3. Comments and Responses

This chapter addresses the comments received during the SEQRA public hearing and the public comment period on the DEIS, as well as the NYSDOT comment letter received after the close of the comment period. Please note that excerpts from the transcript are printed as received and spelling of names, etc, have not been corrected. The comments are grouped by subject matter, paraphrased, summarized and referenced to the original source. The public hearing transcript is in Appendix A and all letters received are in Appendix B. These documents are annotated to show the comment number that addresses each comment herein.

Figure 3-1 - Membership History

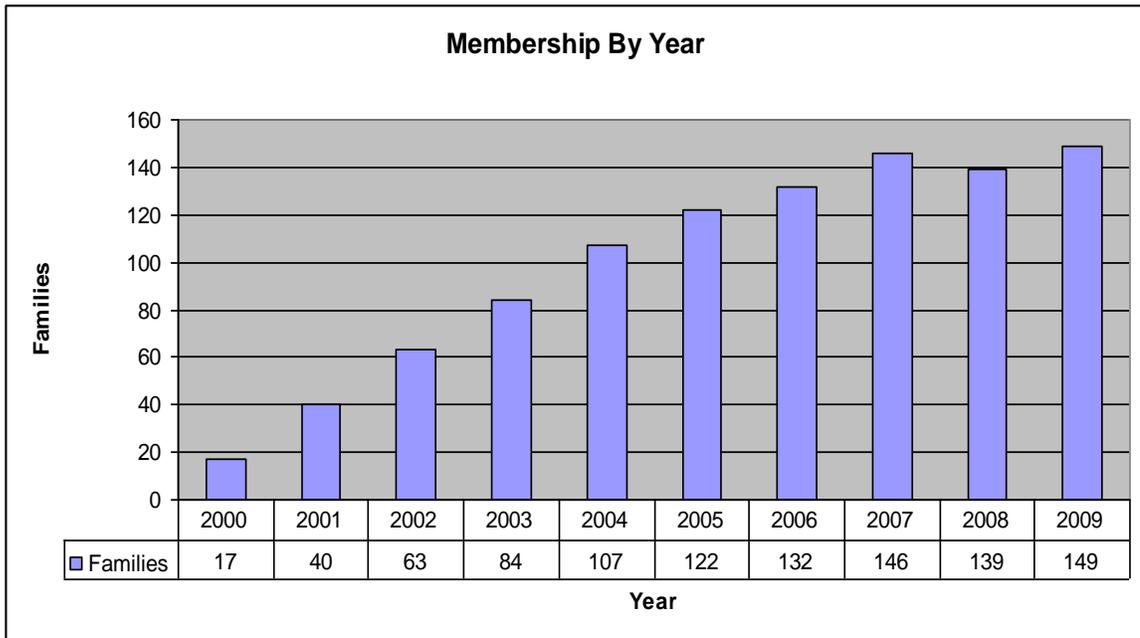
September 24, 2008 Transcript Page 16)

Response: In the past ten years, the congregation has grown from 17 families in 2000 to 149 families in 2009, and has been fairly stable for the past several years (Figure 3-1). Based on this trend, it is quite reasonable that most of the families who would want to join this congregation have already done so, whether or not the congregation has its own building or shares space with the Brookville Reformed Church. As shown in the table below, after an initial growth, the congregation has been fairly stable for the last several years. In other words, this congregation has already achieved much of its growth potential, which is not specifically related to its location.
